Item 78

REMOVAL OF SALISBURY DIFFERENTIAL UNIT

To correct the adjustment procedure of the turnbuckle on the axle spreader tool 18G131C in French and German versions of the Land-Rover Repair Operation Manual.

1RC198B
Fig. 1 Axle spreader tool 18G131C

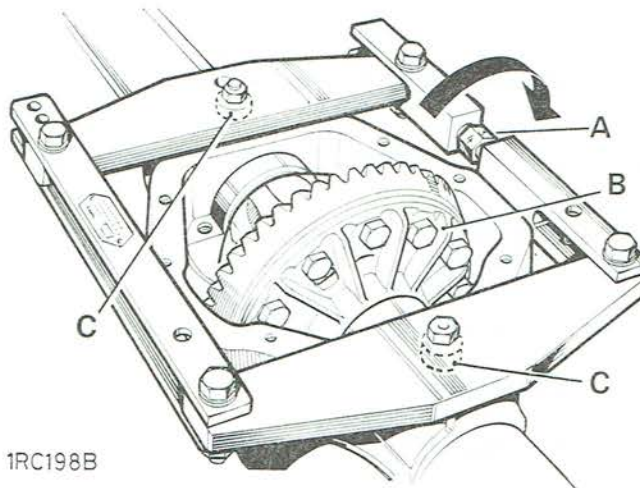
The '**CAUTION**' note in the workshop procedure concerning the adjustment of the turnbuckle on the axle spreader tool 18G131C in the French and German versions of the Repair Operation Manual is based on an earlier English version. This should be corrected to conform to the current details in the Repair Operation Manual, English, Part No. 607314, Operation 51-15-01 sheet 2 as follows:

CAUTION. To prevent permanent damage to the gear carrier case it must not be over-stretched. Each flat on the turnbuckle is numbered to enable a check to be made on the amount turned. The **maximum stretch permitted** is 0,30 mm (0.012 in.), equivalent to **three flats**.

Fig. 2 Clearance between brake pipes and accelerator return spring

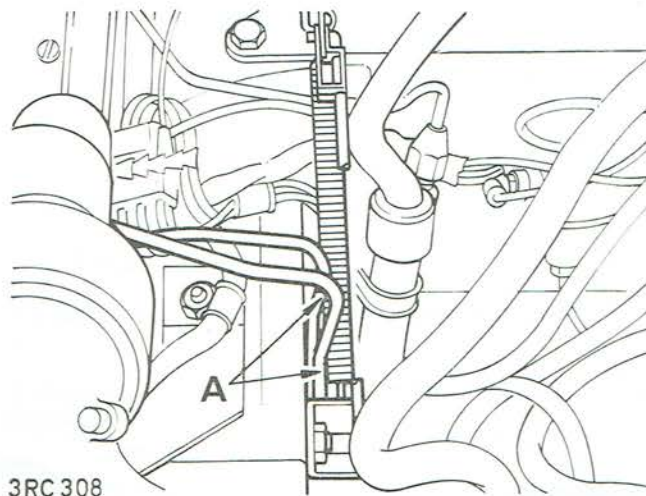
Item 80**SUBJECT: BRAKING SYSTEM****MODELS:** Land-Rover Series III, RH STG equipped with dual braking system.**OBJECTIVE:** To ensure dual brake pipes do not foul the accelerator control rod return spring.**REMARKS:** A limited number of the above vehicles have been produced with a minimal clearance between the accelerator control rod return spring and the dual brake pipes leading from the tandem brake reservoir to the five-way branch union situated on the right hand side of the chassis.

It is possible that in certain instances of vehicle operation or servicing the clearance between the accelerator spring and the brake pipes may be reduced, leading to a chafe condition. You are therefore requested to check for this condition on vehicles which pass through your workshops at the normal service intervals and, if necessary, reposition the pipes to create adequate clearance.

A — Check for clearance at these points

The condition has now been rectified on current vehicles.
